NOTICE OF NON-PERFORMANCE

INSPECTION REPORT

Electrical Corporation:	PacifiCorp
Report Number:	PAD_PC_IAG_20260520_1029
Inspector:	Ivan Garcia
WMP Year Inspected:	2025
Quarterly Data Report (QDR) Referenced:	Quarter 3 (Q3)
Inspection Selection:	Energy Safety viewed the contents of the Q3 QDR and performed an analysis that resulted in the selection of the WMP initiatives and locations referenced in this report.
Relevant WMP Initiative(s):	8.1.2.12 – Expulsion Fuse Replacements
Date of Inspection:	May 20, 2026
City and/or County of Inspection:	Fort Jones, Siskiyou County
Inspection Purpose:	Assess the accuracy of PacifiCorp's QDR data, completeness of its work, and performance of WMP requirements.

Deficiency 1

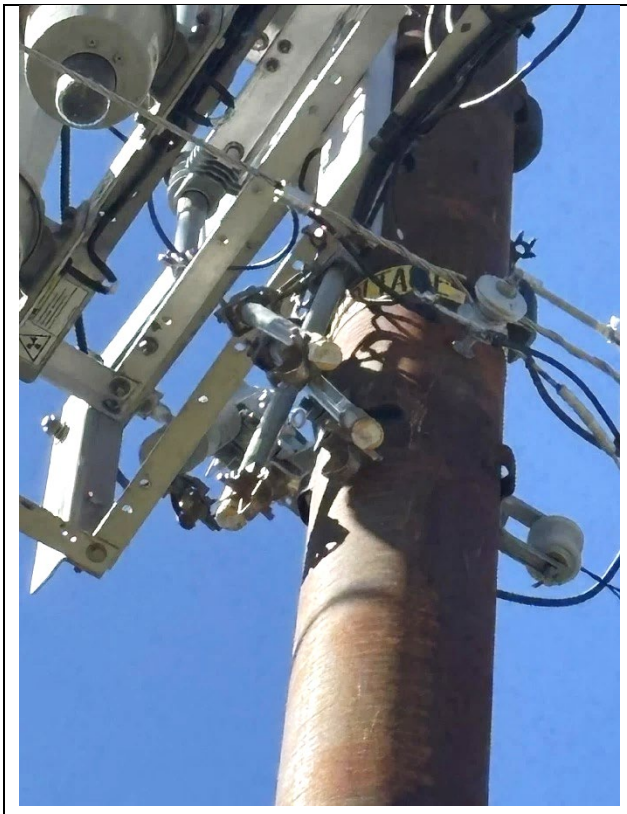
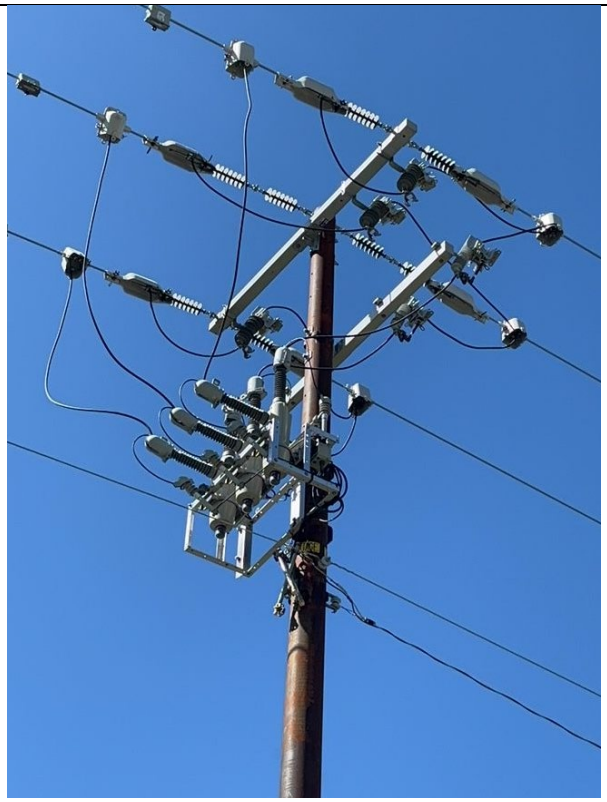
In the 2025 Q3 Quarterly Data Report Submission, PacifiCorp reported that work on WMP initiative 8.1.2.12 – Expulsion Fuse Replacements were completed at Structure ID 06243009.0132501, Grid Hardening ID 7368945 at 41.578971, -122.834518. At this location, the inspector observed three CALFIRE-approved non expulsion fuses that were not installed in the pole's cutouts, but were rather hanging from the pole itself. The inspector's observation is documented in Deficiency 1 photographs, which are attachments to this report. Photo numbers Asset Image 1 and Asset Image 2 depict incomplete installation of CALFIRE-approved non expulsion fuses.

1. Three CALFIRE-approved non expulsion fuses were not installed in the cutouts at the subject pole.
2. Three CALFIRE-approved non expulsion fuses were observed hanging from the subject pole.

Deficiency 1. Energy Safety observed that in implementing 2025 WMP initiative 8.1.2.12 – Expulsion Fuse Replacements, PC failed to complete the installation of California Department of Forestry and Fire Protection (CAL FIRE)-approved non-expulsion fuses on Structure ID 06243009.0132501, Grid Hardening ID 7368945 at coordinates 41.578971, -122.834518. Energy Safety considers this non-performance to be in the Minor risk category. PC must complete a corrective action for this deficiency by 12 months from the date of this notice.[1]
